Request by Danny Senf representing Pizza Hut for approval of a conditional use permit (CUP) for Indoor Commercial Entertainment and In-Vehicle Sales and Service uses including site plan approval at 1400 US Highway 51-138.
This proposal is to renovate a vacant building for a restaurant use with a drive-thru. The use and site appears to meet all necessary Comprehensive Plan and zoning requirements. A public hearing and recommendation to Council is necessary for the CUP. The site plan may be approved by the Plan Commission contingent on the CUP approval. The resolutions, application information and staff review are provided.

Remodeling for Pizza Hut

March 3, 2021

I have completed a final review of the proposed conditional use and site plan for Pizza Hut, 1400 US Highway 51-138, Stoughton, WI. (site plan dated 3/3/21) A conditional use public hearing (restaurant and drive-thru uses) and site plan review are planned for the Plan Commission meeting of March 8, 2021. We anticipate Common Council approval of the Conditional Use Permit on March 23, 2021.

SITE PLAN

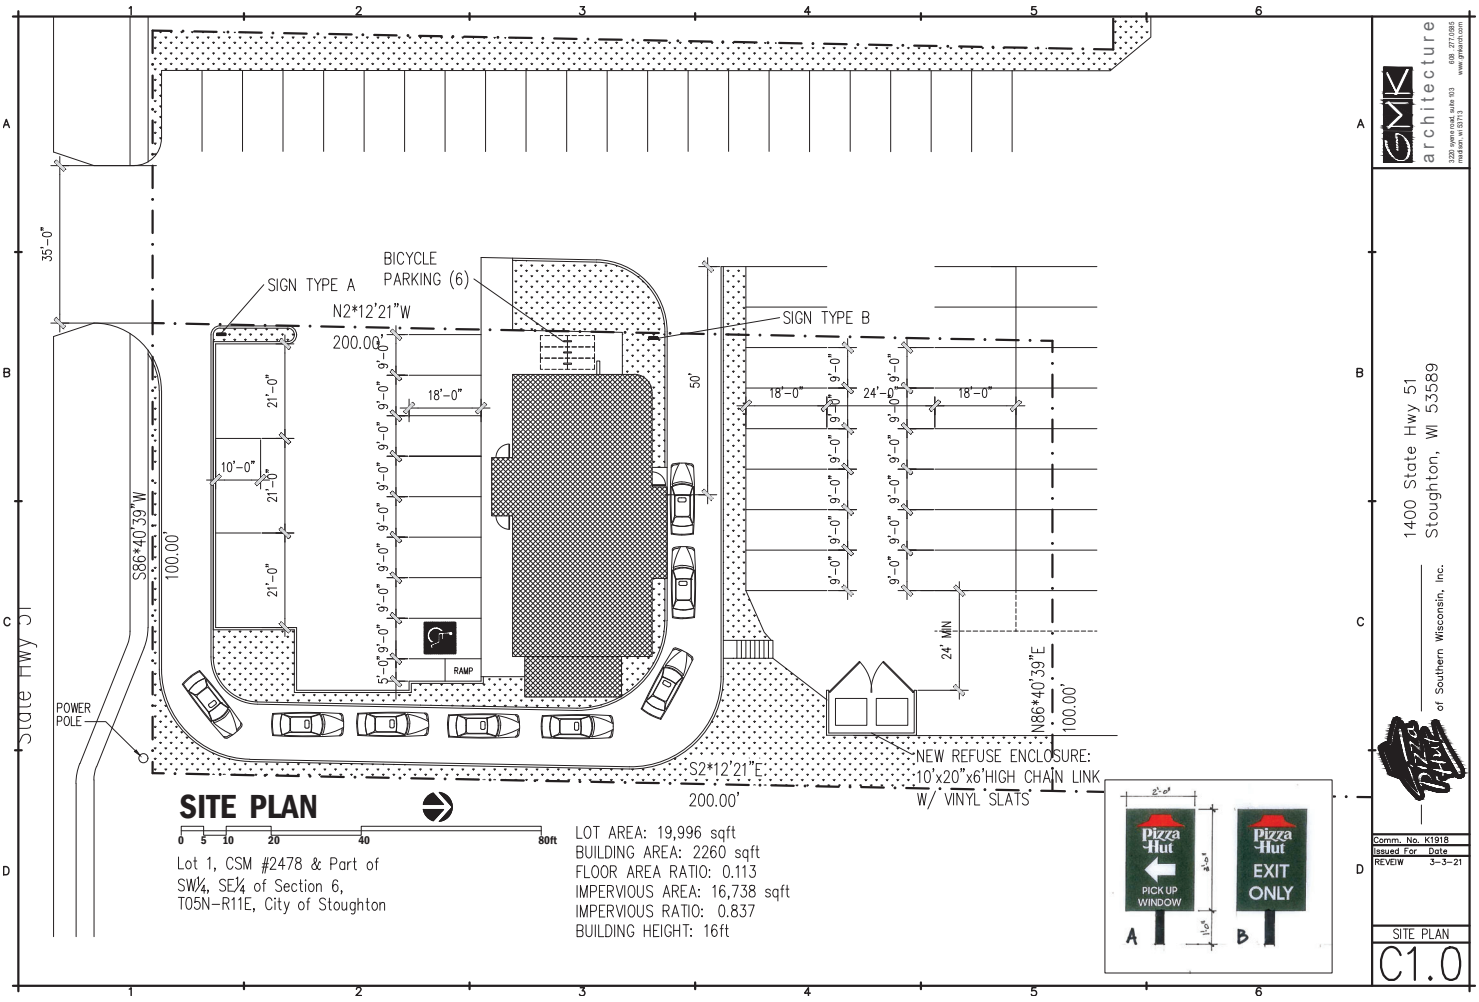
6. The parking requirement for In-Vehicle Sales and Service is as follows: **See parking requirement for Indoor Commercial Entertainment (#3 above).** Each drive-up lane shall have a minimum stack length of 100 feet behind the pass through window and 40 feet beyond the pass through window. **The site plan meets these requirements.**

13. Except for accessible parking stalls, the minimum parking stall length shall be 18 feet with a minimum width of 9 feet. **The plan meets this requirement.**

14. The parking aisle width for 90-degree parking shall be a minimum of 24 feet. **The plan meets this requirement.**

15. The minimum landscape surface ratio (LSR) is 25%. **The site is existing and it appears to have approximately 16% coverage.**

22. The minimum paved surface setback from a side and rear lot line is 5 feet while the minimum is 10 feet from a right-of-way line. **The existing paving does not meet this requirement.**

23. Per section 78-704 (13) (a), bicycle parking is required equal to 10% of the automobile parking space requirement. **The plan appears to meet this requirement.**

LANDSCAPE PLAN

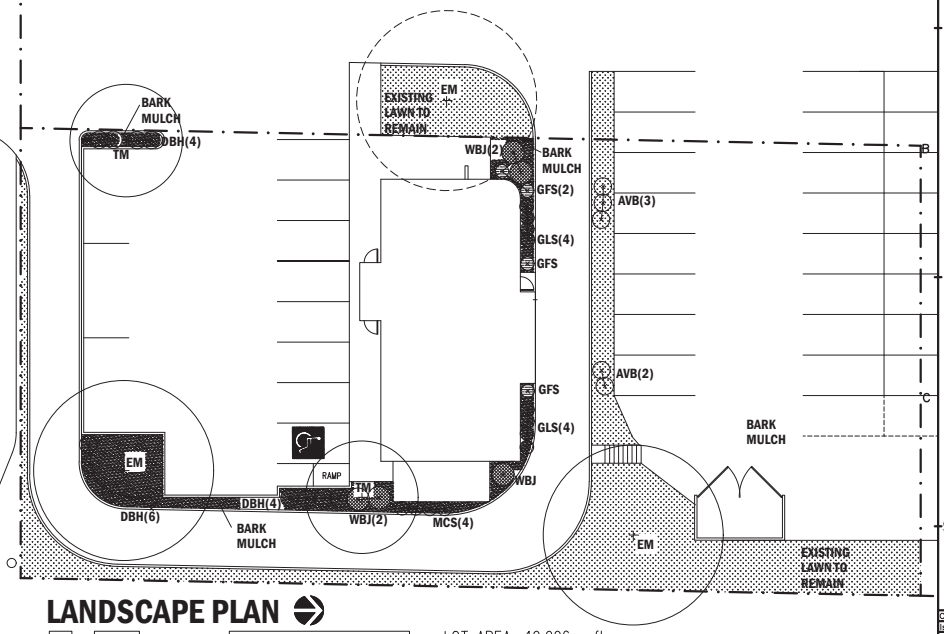
26. The existing landscaping was previously approved. **Provided landscaping plan meets necessary requirements.**

CONCEPTUAL RENDERING (*MAY NOT BE TO EXACT SCALE)

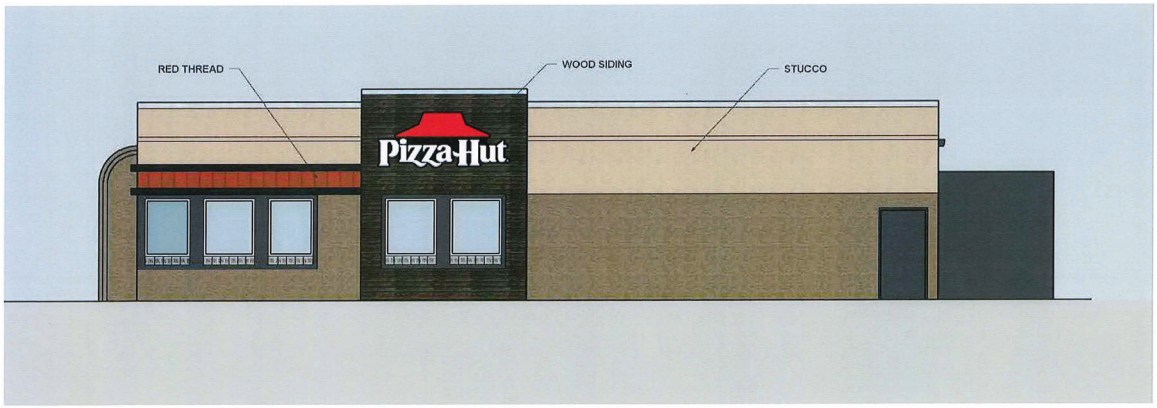
32. Any proposed signage will require a detailed plan and zoning permit prior to installation. **Wall and directional signage are shown on the plan. The existing pole at the front of the lot is planned to be removed.**
